BCA Assessment Report

78 Lockwood Road Data Centre
78 Lockwood Rd, Erskine Park

Revision 5

24 March 2026

Figure 2 – Undercroft link between eastern & western portions of Large Isolated Building

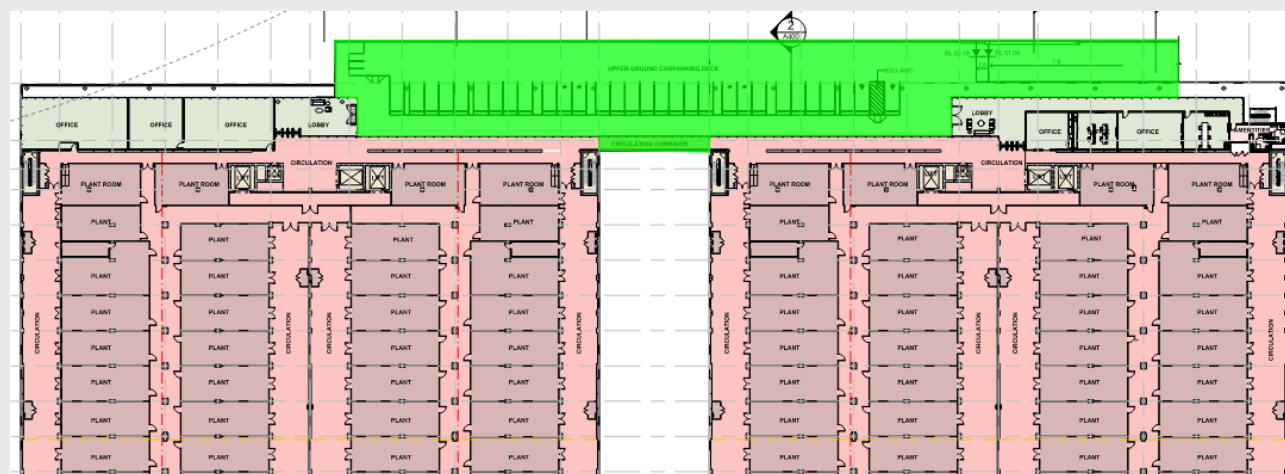
Note 2: Large Isolated Building – The eastern and western portions of the main Data Centre building are connected at the Lower Ground Level by the external carpark slab over (see Fig 2 below). As a result they have been assessed as a single Large Isolated Building pursuant to
